Product Change Notification

(Notification – P2203015-DI)

The purpose of this notification is to communicate a product change of select Renesas Electronics America, Inc. (REA) devices.

This notification announces one or more of the following assembly changes for select M16C and M32C devices.

Figure6

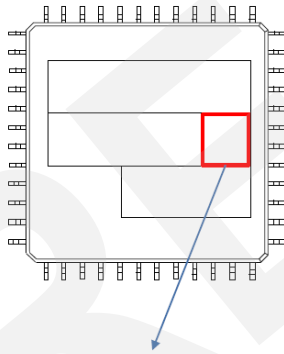
The "Product Code" (2 characters) printed here will be changed.

Figure7

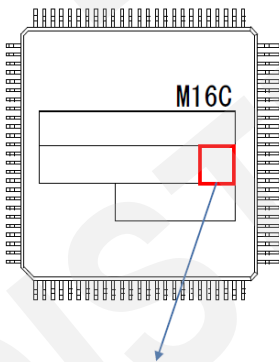
The "Product Code" (2 characters) printed here will be changed.
